## APPENDIX C: PUBLIC PARTICIPATION MATERIALS

# NOTICE OF APPLICATION FOR A PROSPECTING RIGHT AND ENVIRONMENTAL AUTHORISATION

## ORION EXPLORATION No. 5 (PTY) LTD, EXPLORATION PROSPECTING, COPPERTON, SIYATHEMBA LOCAL MUNICIPALITY, NORTHERN CAPE

Figure 1: Location of the Prospecting Boundary

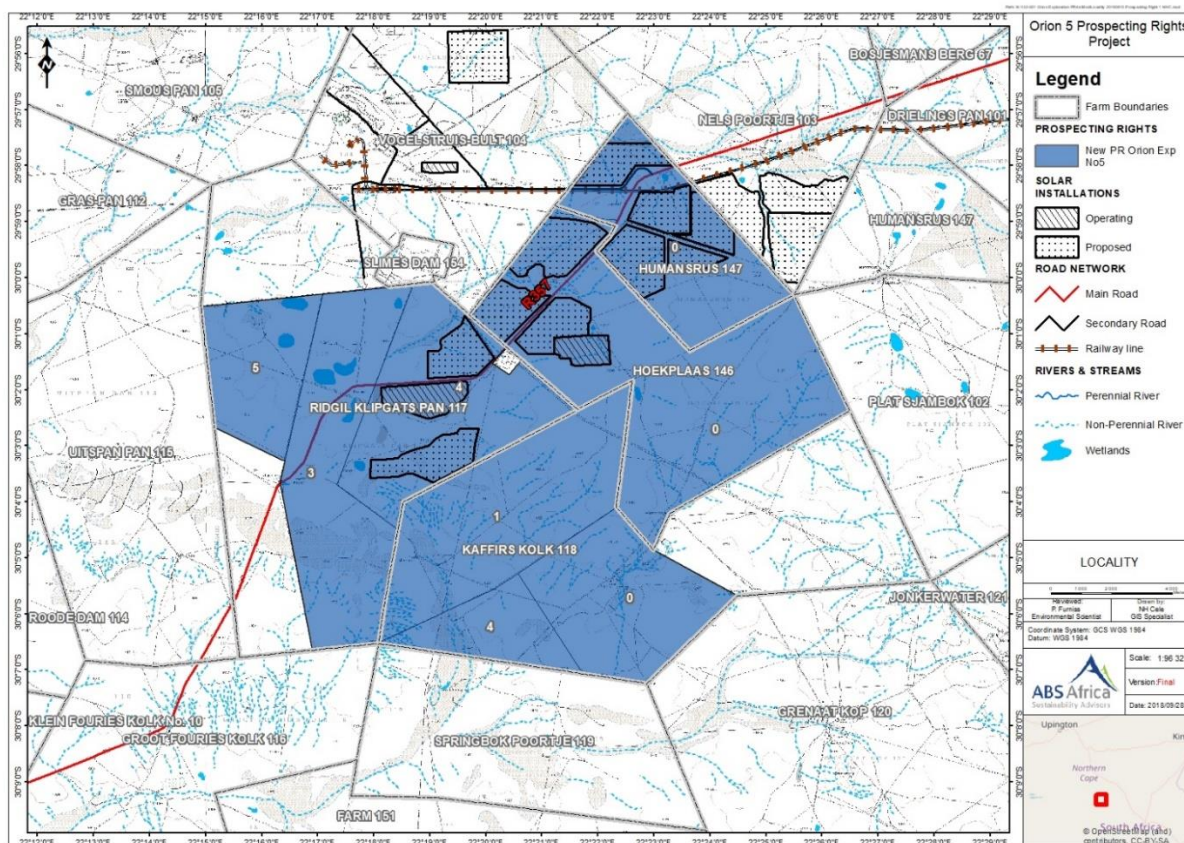
<p>Sonia Miszczak Atlantic Renewable Energy Partners</p>	<p>Atlantic Renewable Energy Partners (Pty) Ltd ("AEP") is developing four solar PV facilities on the farm Humansrus 147 – these are already shown in Figure 1: Location of the Prospecting Boundary.</p> <p>AEP objects to any prospecting activities and subsequent mining activities over the entire farm Humansrus 147. The proposed solar projects are at an advanced stage of development; each project has a valid Environmental Authorisation and it is the intention of the Developer to see these to commercial fruition. AEP holds a valid land option agreement and it is our intention to develop additional projects over the remaining space on farm Humansrus 147.</p> <p>Invasive prospecting near the solar PV energy facilities could have a detrimental impact on the proposed facilities if the invasive prospecting creates dust, which would impact the efficiency and yield of the solar panels. Additionally, trenching in or near operational facilities could pose a risk to the facility. The potential for vibrations could also be detrimental to the integrity</p>	<p>Atlantic Renewable Energy Partners (Pty) Ltd ("AEP") is developing four solar PV facilities on the farm Humansrus 147 – these are already shown in Figure 1: Location of the Prospecting Boundary.</p> <p>AEP objects to any prospecting activities and subsequent mining activities over the entire farm Humansrus 147. The proposed solar projects are at an advanced stage of development; each project has a valid Environmental Authorisation and it is the intention of the Developer to see these to commercial fruition. AEP holds a valid land option agreement and it is our intention to develop additional projects over the remaining space on farm Humansrus 147.</p> <p>Invasive prospecting near the solar PV energy facilities could have a detrimental impact on the proposed facilities if the invasive prospecting creates dust, which would impact the efficiency and yield of the solar panels. Additionally, trenching in or near operational facilities could pose a risk to the facility. The potential for vibrations could also be detrimental to the integrity</p>	<p>The prospective solar PV facilities on Humansrus were identified and the impacts of the proposed prospecting activities on these facilities have been considered in the BAR.</p> <p>The current application is for a small-scale, temporary and low-impact prospecting activity. It is possible that the prospecting will be complete and any disturbance rehabilitated before construction of the prospective and future planned solar PV facilities on Humansrus commences.</p> <p>Diamond-core drilling does not generate any dust during the drilling process. It is specifically for this reason that this drilling technology is being proposed.</p> <p>Further, mitigation measures for controlling dust from access tracks and site preparation activities</p>
